VOLUME 3	GROUP Body	MODEL 2009 Rio (4 door)
		NUMBER 042	DATE November 2008

TECHNICAL SERVICE BULLETIN

SUBJECT:
SERVICE ACTION: 2009 RIO FUEL DOOR ADJUSTMENT (SA004)

Fuel Filler Door Adjustment

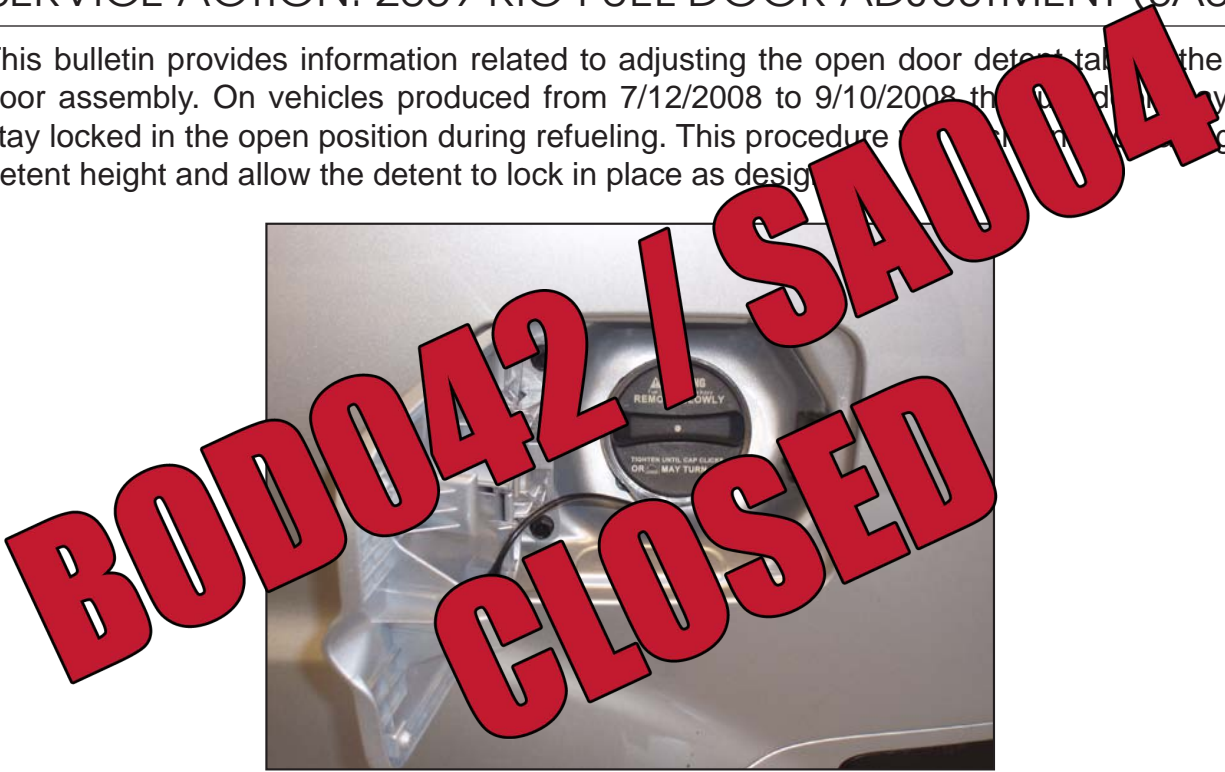
This bulletin provides information related to adjusting the open door detent for the fuel door assembly. On vehicles produced from 7/12/2008 to 9/10/2008 the fuel door may not stay locked in the open position during refueling. This procedure involves adjusting the detent height and allow the detent to lock in place as designed.

7. Check to make sure the fuel door is centered and adjusted properly before releasing vehicle back into service.
